SERVICE BULLETIN

224
No.

Piper Aircraft Corporation

SUBJECT: Mitchell Bulletin No. A55 — Modification of Pitch Servo

VIEW LOOKING DOWN THROUGH FLOORBOARD ON PILOT'S SIDE

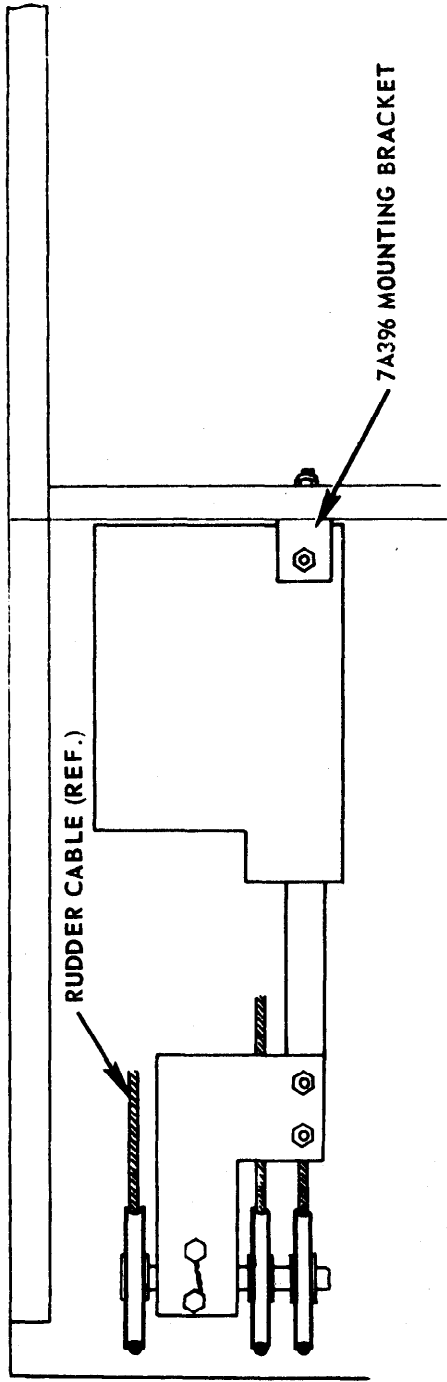
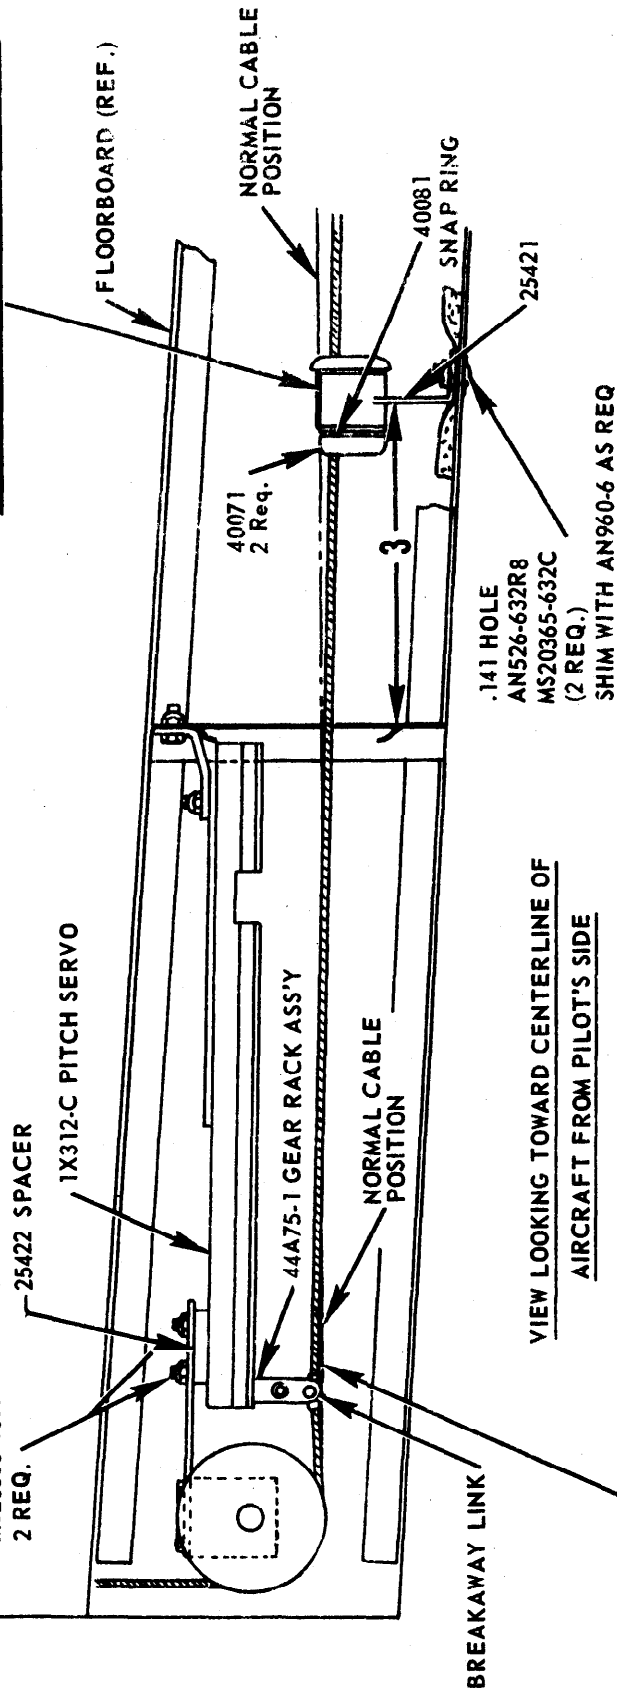
1. See Piper Electronic News Letter No. EL-48 for lubrication instructions
2. See attached sketch for details and installation of fairlead which is a part of this modification.

Install this bracket so the upper portion of the fairlead contacts the top of the cable. Use shim washers between skin and bracket to prevent cable deflection of more than 1/8 inch from its normal position.

Cable must have upward deflection of 1/16" thru full travel of rack assy.

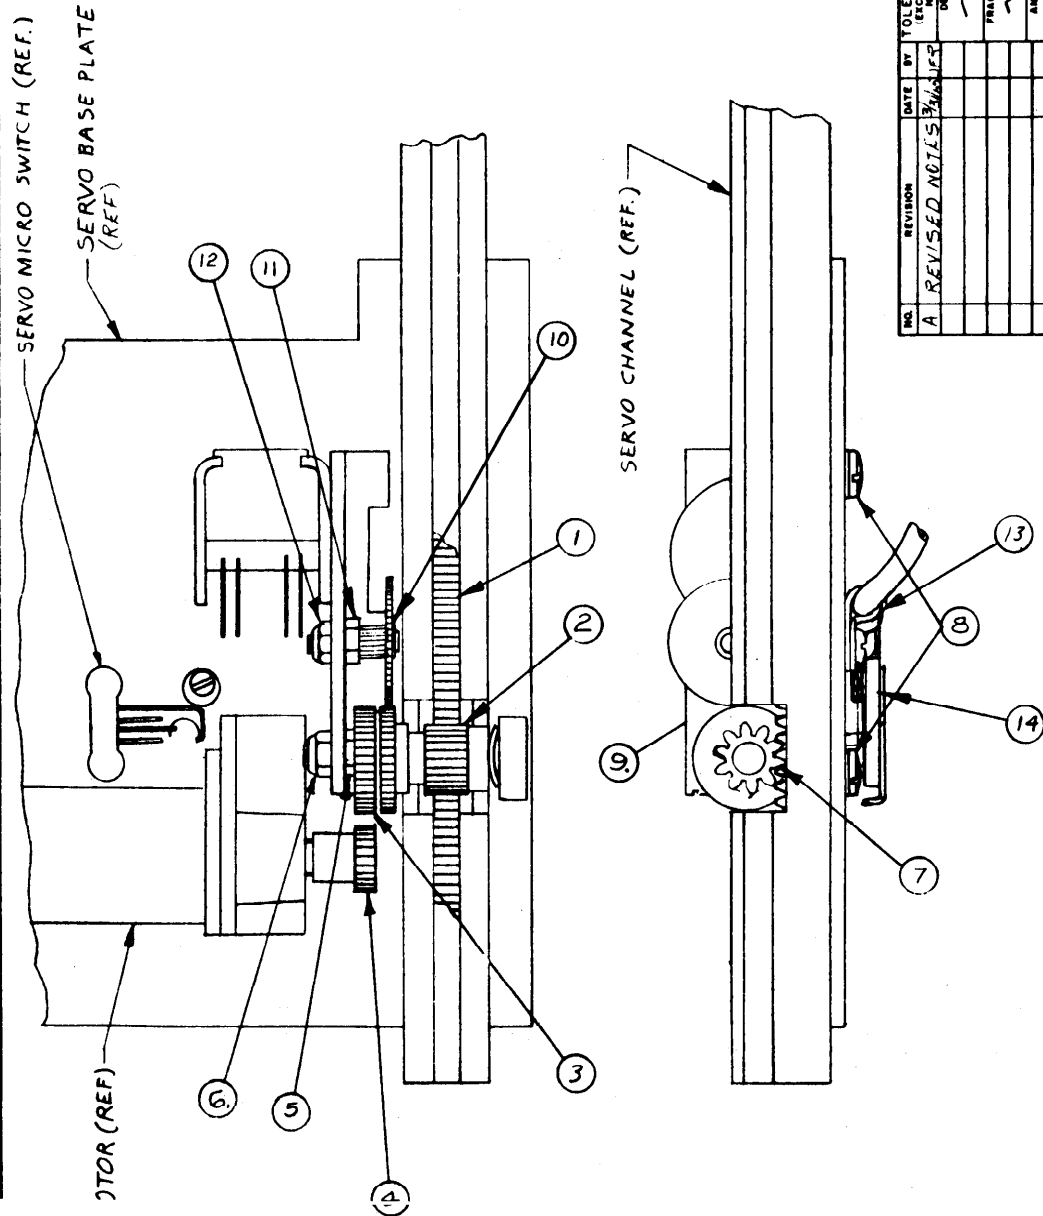
1. Disengage servo motor to obtain clearance between motor gear (4) and gear train (3).
2. Slide gear rack (1) into servo channel and under pinion (2). Move gear rack to both extremities in small increments to determine if gap (7) has minimum backlash and rack is free from binding.

3. If not properly adjusted, loosen gear train lock nut (6) and using a 1/2" open end wrench no thicker than 1/16", rotate gear train cam (5) until gear rack (1) will slide freely into position under pinion (2).

4. Idler gear (10) may have to be repositioned to obtain adequate clearance for adjustment of gear train (3). Loosen lock nut (12) and rotate cam (11) to obtain clearance.

5. Adjust cam (5) for minimum backlash between pinion (2) and gear rack (1) without binding.
6. Repeat step 2. to insure proper pinion adjustment.
7. Tighten lock nut (6) while holding cam (5) with 1/2 x 1/16 wrench.

8. Readjust idler gear (10) for minimum backlash without binding to gear train (3) by rotating cam (11), then tighten lock nut (12) securely.
9. Engage motor and observe mesh between motor gear (4) and gear train (3).

10. Servo motor micro switch should make contact before gears (4) and (3) start to mesh. If necessary, gear train support bracket (9) may be adjusted in either direction by loosening clamp screws (8).

11. Recheck all above points after screws and nuts are tightened.
12. After installation in aircraft, the servo lever (13) travel and engage control knob on console may be coordinated by slipping cable housing in the appropriate direction thru housing clamp (14).

DRAWING NO: 69D326
 INSTALLATION DRAWING
 FOR PITCH SERVO IN
 PIPER ALTIMATIC II
 MITCHELL INDUSTRIES INC.
 MUNICIPAL AIRPORT
 MINERAL WELLS, TEXAS

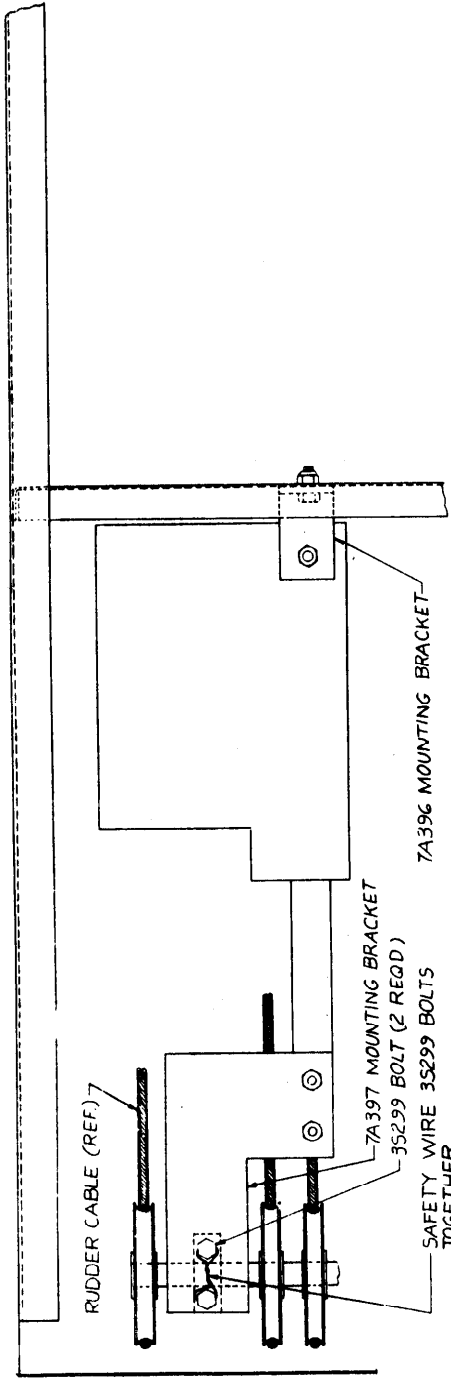
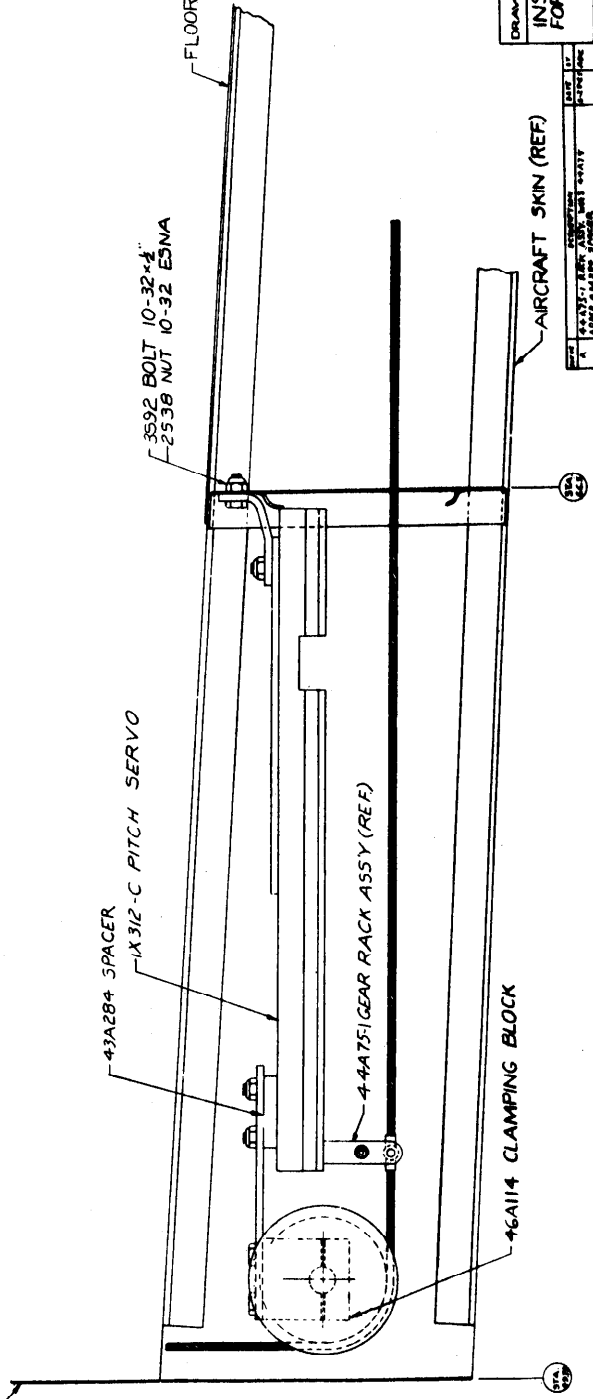
There have been several reports of interference occurring between the pitch servo rack assembly and the screw heads of the AN510-10R16 screws that attach the forward end of the servo to the forward mounting bracket. These screw heads should be inspected to be sure they are flush.

If the screws are not flush, then the pitch servo spacer block, part number 25422 should be removed and the two (2) holes increased to 1/4" diameter. Any subsequent installation should have the holes in the pitch servo block, part number 25422, drilled to 1/4" before it is installed.

PART NO. 44A75 1
 ISSUE A
 CHANGES
 MEMO.
 A 45A51 WAS 45A51 B
 BH. ADDED 3E R,
 & NOTE 3. E0180R JFR 3/23/64

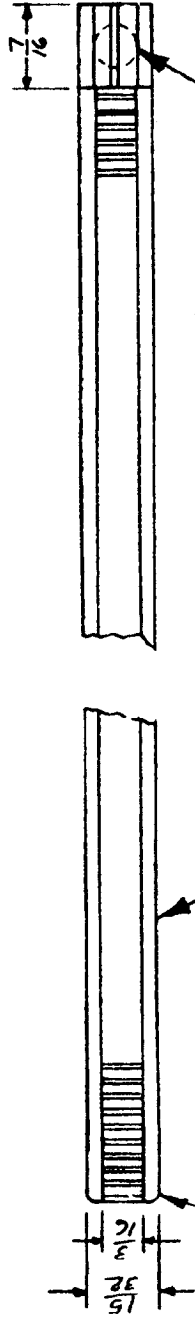
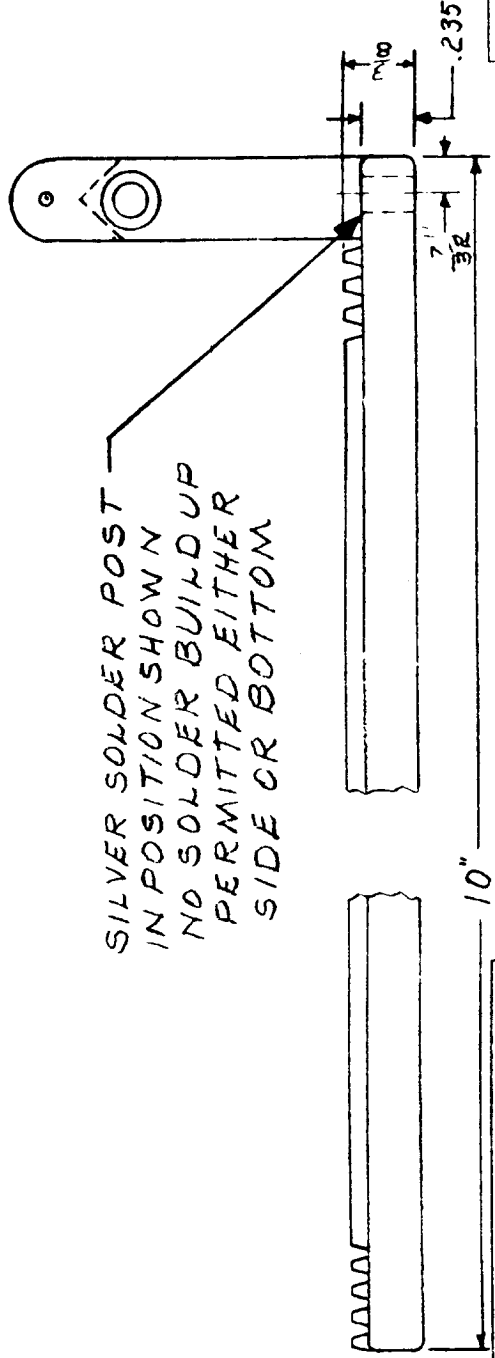
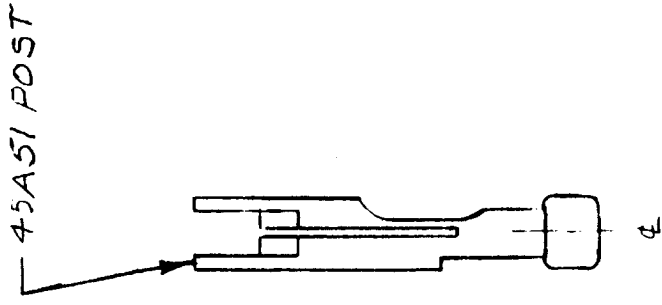
- NOTE:
1. TEETH TO BE REMOVED $\frac{7}{16}$ " FOR POST MOUNTING.
 2. POLISH BOTTOM SURFACE BEFORE AND AFTER PLATING.
 3. PART TO BE FREE OF ALL BURRS.

10M71 GEAR RACK
 MINIMUM OF $\frac{3}{32}$ " R. ON CORNERS OF EACH END OF RACK

SILVER SOLDER POST IN POSITION SHOWN
 NO SOLDER BUILDUP PERMITTED EITHER SIDE OR BOTTOM
